FINAL Results of the Flint Surface Water Treatment Plant Evaluation

April 25-28, 2016

Prepared By Sleeping Giant Environmental Consultants, LLP

For Eastern Research Group, Inc. (ERG) and U.S. Environmental Protection Agency Office of Civil Enforcement

Figure 1 – FSWTP Performance Potential Graph

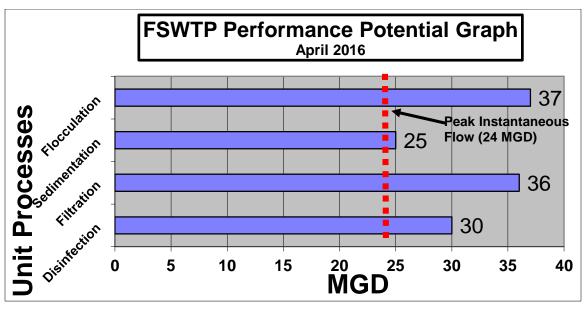
The shortest bar (sedimentation) likely represents the major unit process that potentially most limits the plant's compliance capability. However, sedimentation is unlikely to be a limiting factor unless the turbidity and/or TOC of the KWA water are much greater than expected.

As shown by the graph (and the criteria and assumptions listed below), the plant is judged to have the capacity to meet regulatory requirements. The criteria and assumptions used to assess each major unit process are outlined in the notes below the performance potential graph and described in more detail in the following text.

As shown in Figure 1, SGEC's assessment is that the FSWTP's major unit processes will not limit the FSWTP from effectively treating the KWA water. The plant was originally constructed more than 50 years ago, but was originally well designed and has benefitted from recent upgrades.
